Jimblebar Hub Significant Amendment: Response to Submissions ADDENDUM

Table A: Additional responses to comments, received 5 to 8 August 2025

Attachment B Jimblebar Terrestrial Fauna EMP

Attachment C Consolidated fauna habitat map

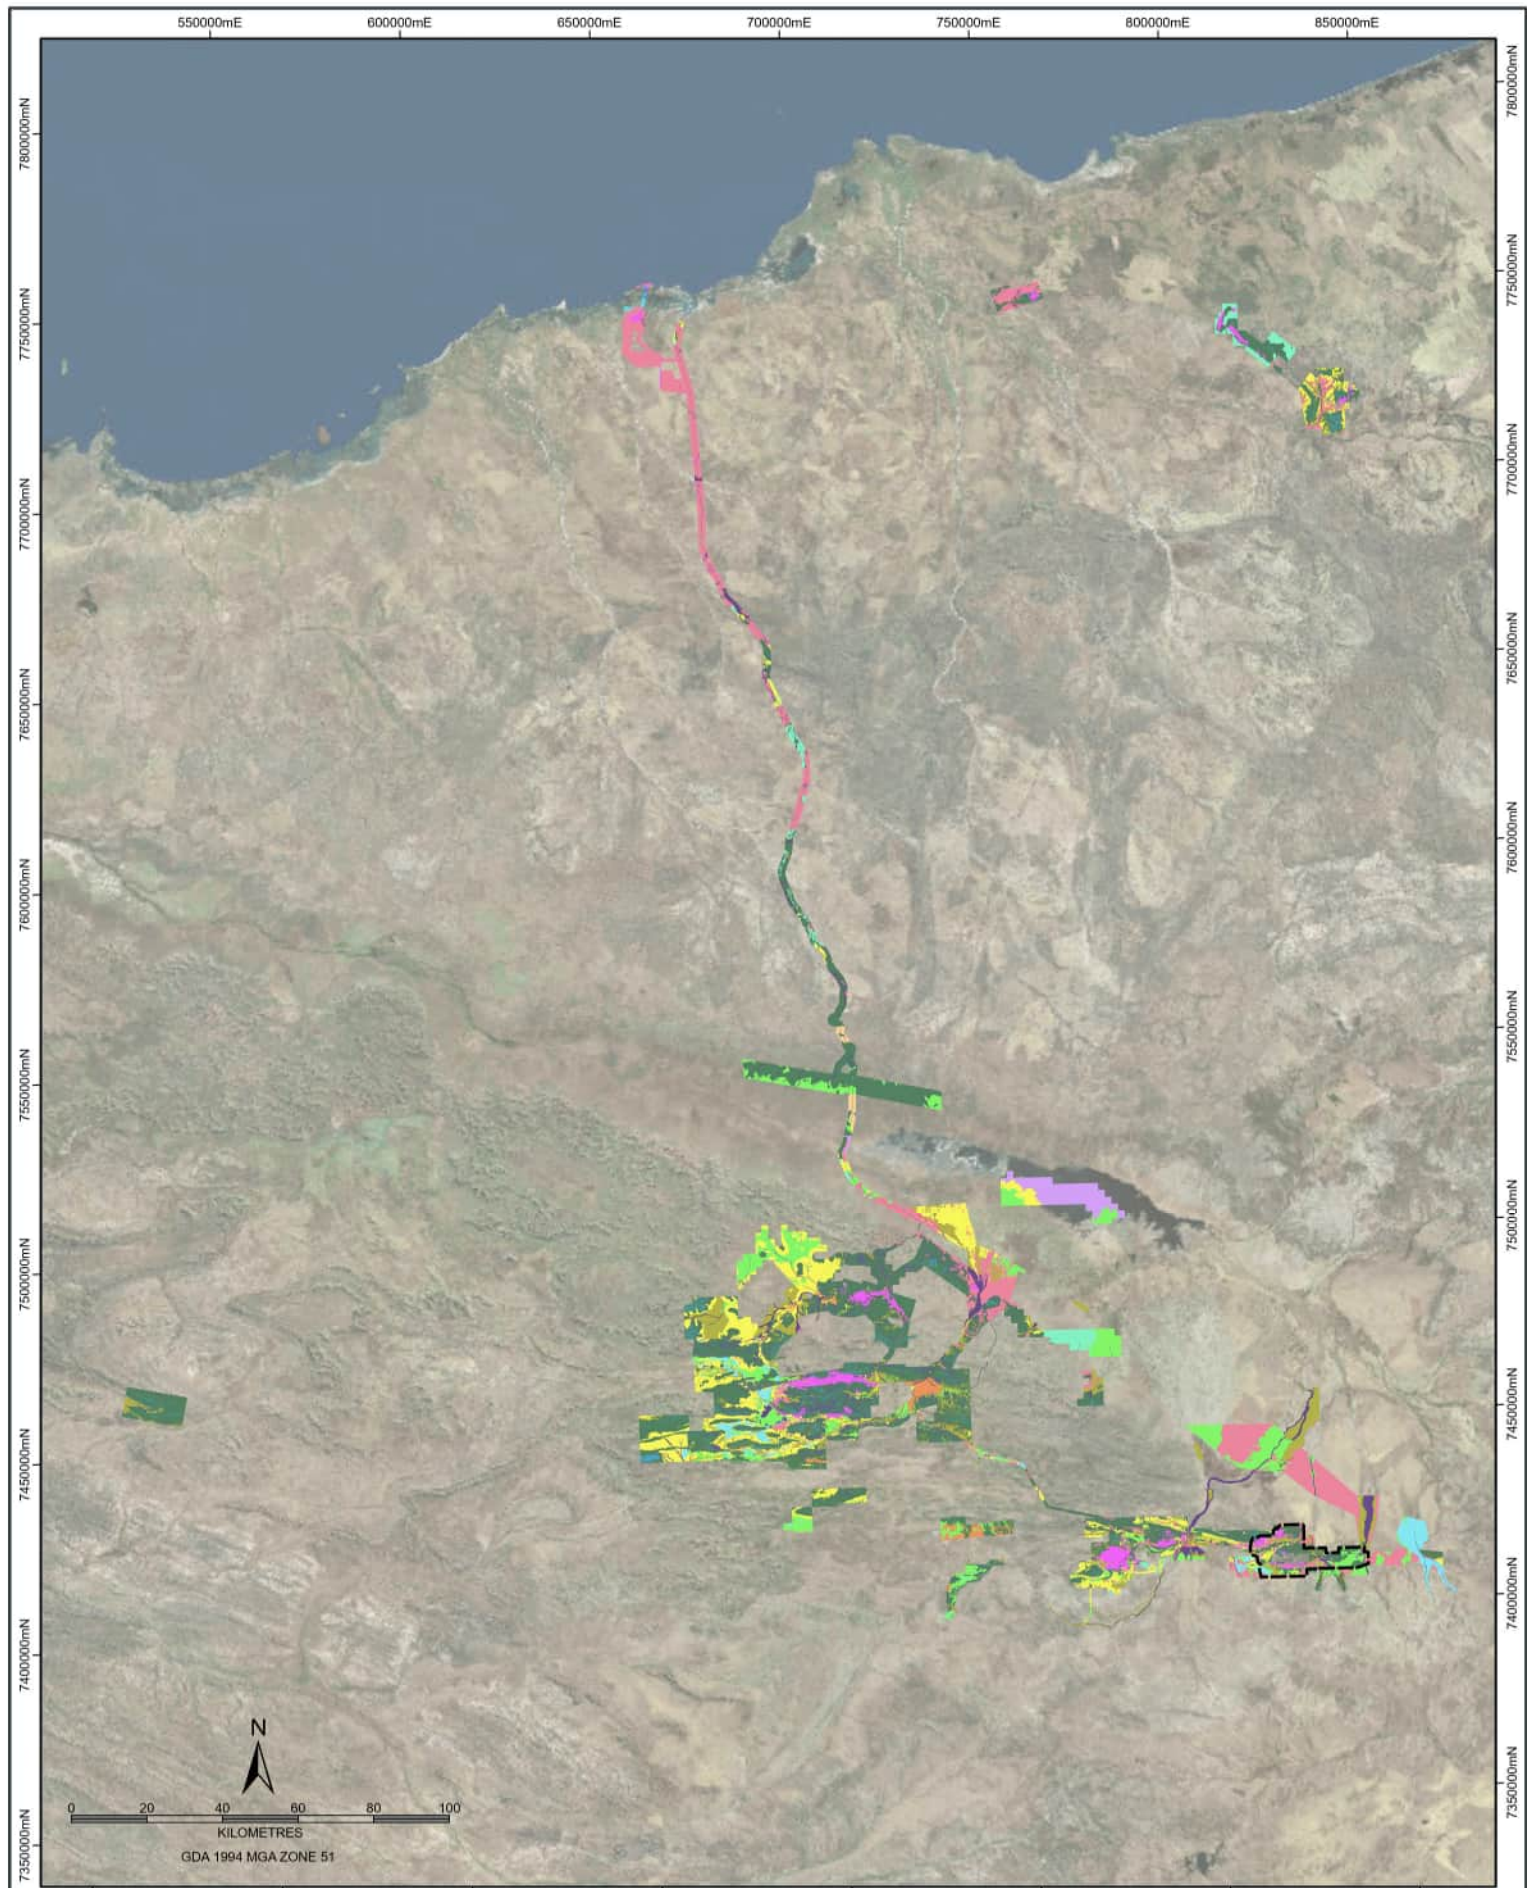
4	6/8/2025	Please confirm the below 2 statements are correct: - Caves CJIM-09 and CJIM-20 were assessed as part of the approved proposal (MS 1126), however BHP have applied a 100 m MEZ over these caves, which will not be cleared as part of the approved proposal (MS 1126). - The only cave which may be cleared for the proposal (significant amendment and approved proposal) is cave CJIM-04, which does not have an MEZ.	A 100m buffer will be applied to caves CJIM-09 and CJIM-20 to ensure these caves are retained and protected. CJIM-04 is outside of the Indicative Footprint, but does not have a buffer and therefore has the potential to be impacted. Based on the current design, it is located approximately 80m from an overburden storage area. BHP updated and provided the Jimblebar Terrestrial Fauna EMP to correct an error in the Appendix. See Attachment B .
5	8/8/2025	Please clarify / define what the 'Area within BHP Consolidated Mapping (ha)' is in table 9-5 of the ERD? Is there a map showing where this area is or can you provide an idea of where it is in relation to the development envelope?	BHP maintains a GIS layer of consolidated biodiversity mapping across much of its WAIO operations. BHP provided a map of the consolidated fauna habitat mapping. See Attachment C .
